SOUTH CAROLINA ELECTRIC & GAS COMPANY

June 6, 1984

> Subject: Virgil C. Summer Nuclear Station Docket No. 50/395 Operating License No. NPF-12 Inadequate Core Cooling

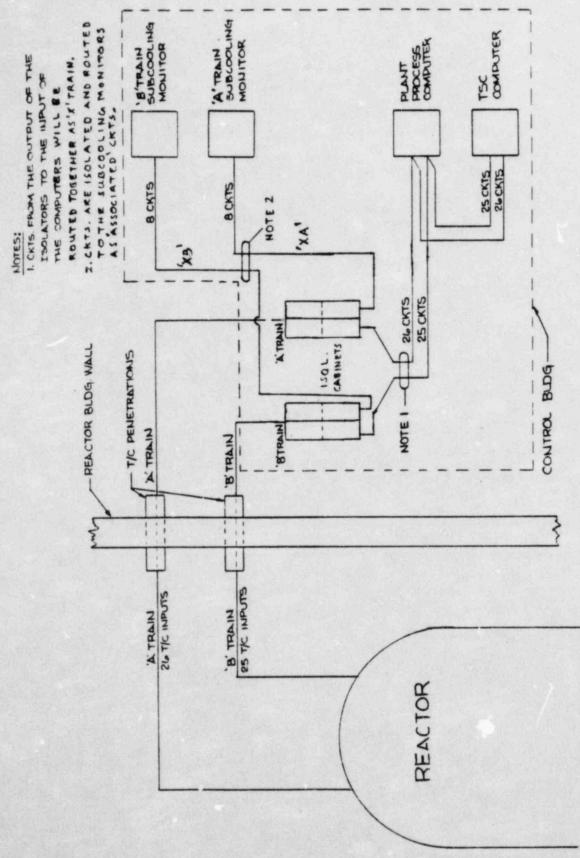
During the implementation review of the Inadequate Core Cooling Instrumentation (ICCI) installation conducted at the Virgil C. Summer Nuclear Station on May 8, 1984, qualification of the backup core exit thermocouple display as raised as an NRC Staff concern. Through subsequent conversations with the Staff, a mutually acceptable design modification was developed which is described below.

As shown in the attached sketch, the thermocouple signals will be routed in two trains, with twenty-five signals in one train and twenty-six signals in the other. With the exception of the area where the thermocouples exit the reactor vessel head, the circuits will be divided into two trains and electrical separation will be maintained. In addition, the circuits will be seismically supported.

Outside the Reactor Building, the circuits will be routed from the penetrations to the thermocouple transmitter/isolation cabinets maintaining electrical separation and utilizing qualified cable and seismic supports. A thermocouple transmitter/isolation cabinet will be provided for each train containing electronic modules which provide cold junction compensation and lE electrical isolation for each thermocouple. This electrical isolation will assure that any credible faults on the non-lE circuits connected to the output of the isolators will not degrade the lE thermocouple circuits. These cabinets will be located in the cable spreading area one floor below the Control Room.

The signals from the output of the isolators will then be wired to the input of two computers. In addition, eight A-Train and eight B-Train signals will be routed through separate isolation amplifiers and input to the respective A-Train and B-Train subcooling monitors. These circuits will be routed to the subcooling monitors maintaining electrical separation and utilizing qualified cable and seismically qualified cable trays and conduit. To be consistent with the separation criteria, these are designated "associated" circuits.
